City of Aurora Building Division
Project: *Tenant Improvement*
Address: *1400 S POTOMAC ST Unit 250*
Occupancy Group: *IBC B*
Construction Type: *UBC II-N-SPK*
RSN: *1652119*
Permit: *22-2201748-LT*

City of Aurora Building Division
Reviewed for Code Compliance
Approved as Noted: *Matt A.*
Date: *Aug 22, 2022*
2015 INTERNATIONAL CODES & 2020 NEC

Sundermeyer Family Practice

CONSTRUCTION DOCUMENTS

A1 **LEVEL 2 - LIFE SAFETY**
1/16" = 1'-0"

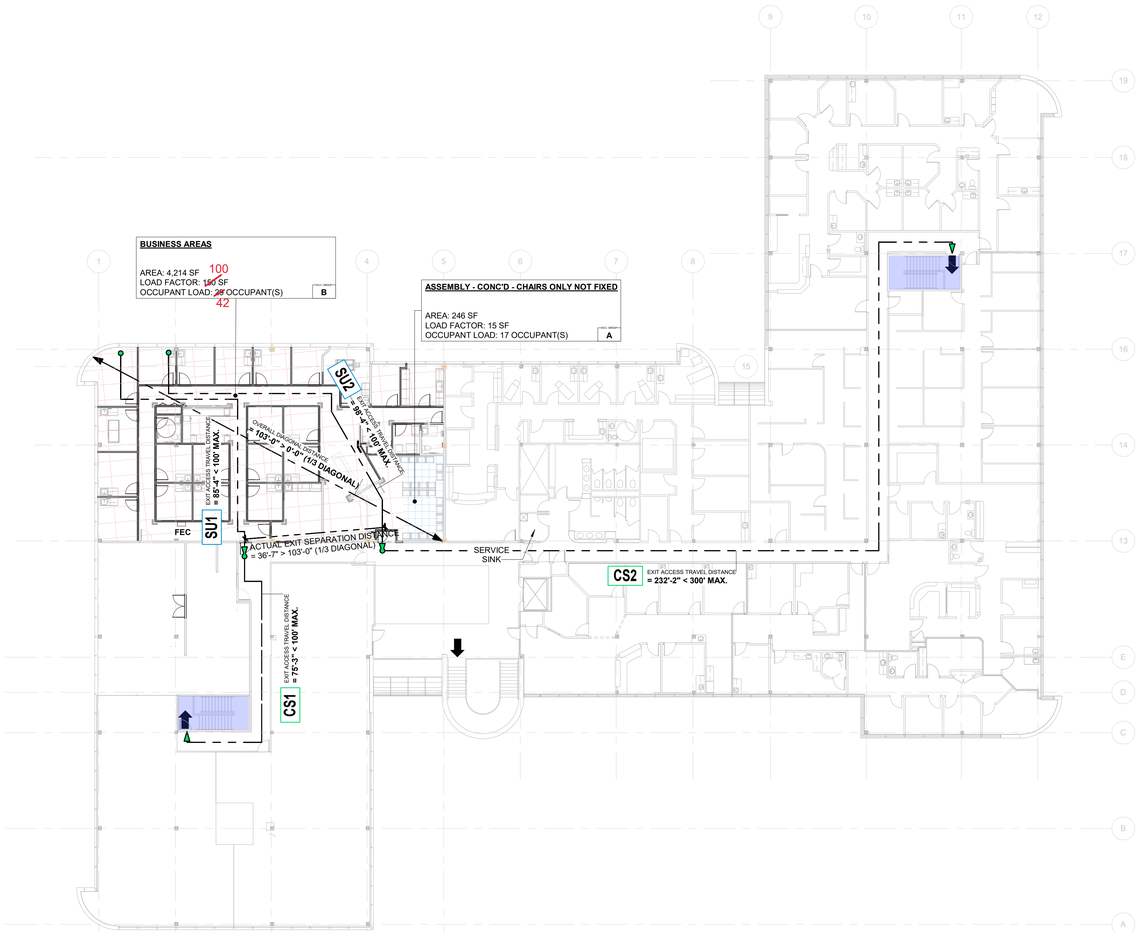
Provide a sign stating "EXIT" in raised, visual characters and braille adjacent to each door in an area of refuge, an exterior area for assisted rescue, an exit stairway or ramp, an exit passageway and the exit discharge. **2015 IBC 1013.4**

C2 **COUNTERTOP - PLAM**
1 1/2" = 1'-0"

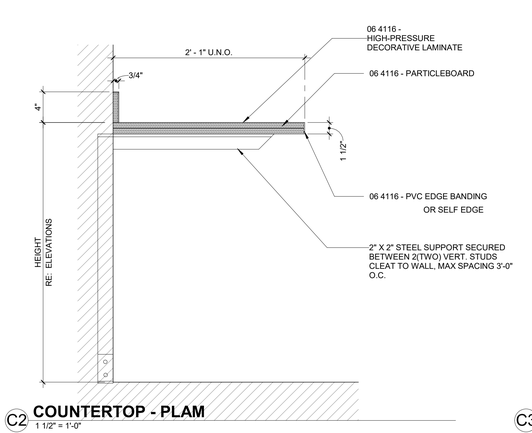
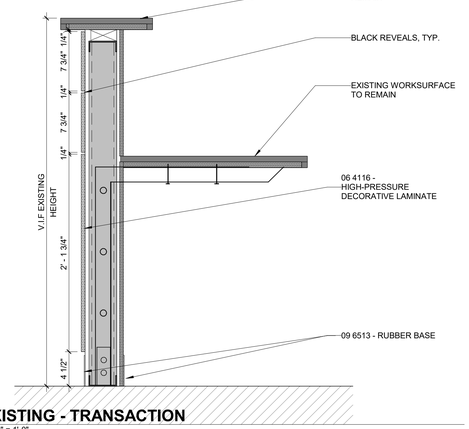
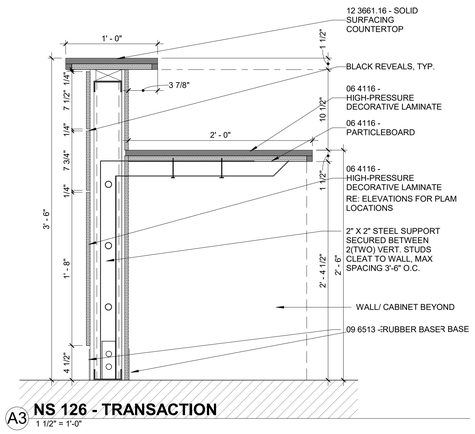
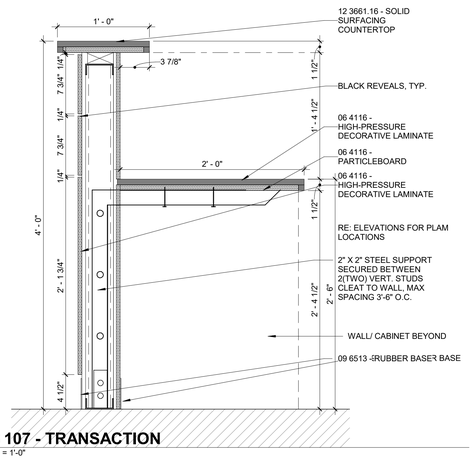
SALES AND SERVICE COUNTERS AND WINDOWS SHALL COMPLY WITH SECTION **904.3, ICC/ANSI A117.1-2009** FOR ACCESSIBILITY REQUIREMENTS

NEW WORK PLUMBING PLAN - LEVEL 2

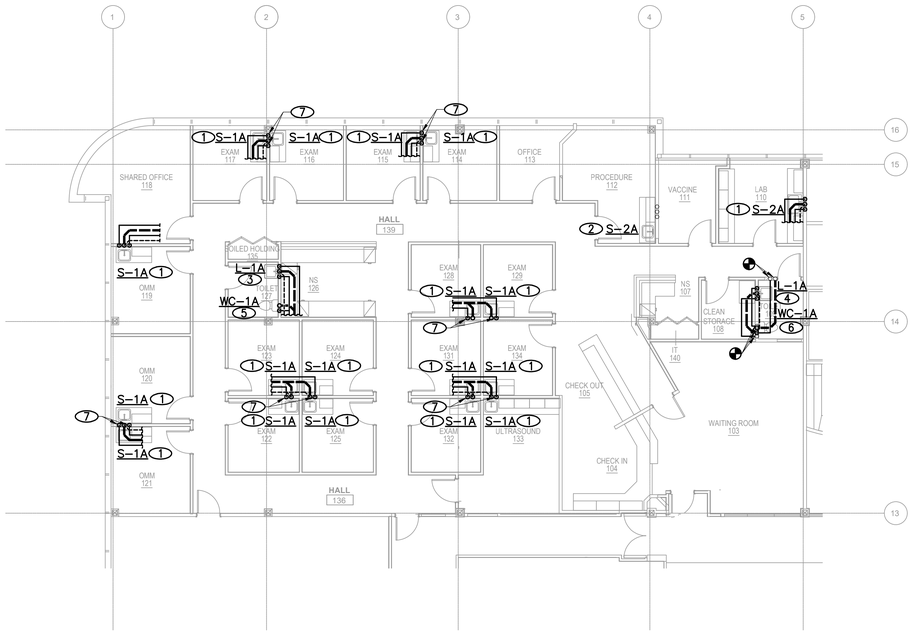
Provide drains no smaller than allowed by **2015 IPC 709.1 and 710.1(1)**

NEW WORK MECHANICAL PLAN - LEVEL 2

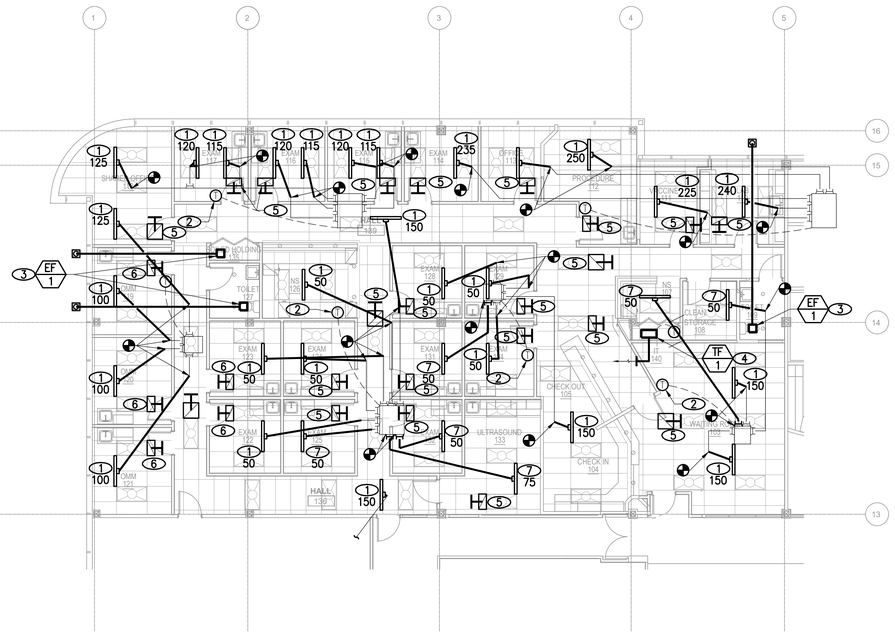
Provide proof of a flame spread less than 26 and a smoke development less than 50 for any material used in a plenum.
2015 IMC 602.2.1
